HR-7-13

#### FMVSS 202a Dynamic Evaluation of the Volvo WHIPS Seat

Ford Presentation to NHTSA

#### Film Analysis: "Phantom" Reference Targets

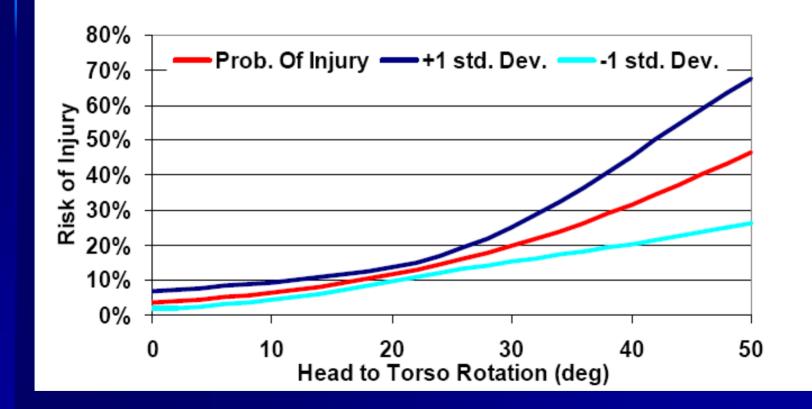
- Based on paired tests of Saab seats with and without the Self Aligning Head Restraint (SAHR)
  - The head-torso rotation was obtained via film analysis using "phantom" reference targets (Viano).
    - Not the method required by FMVSS 202a where instrumentation error is +/- 1.5 deg compared to film analysis (Voo et al., SAE 2003-01-0174).

- Increase the head-to-torso rotation limit to 20°
  - Approximately represents a 11% risk of whiplash injury (AIS 1) according to the NHTSA probability curve.
  - Significantly lower than the 18.8% injury risk level allowed for moderate head injuries (AIS 2) by the HIC requirement of 500.
  - Will be less design restrictive.
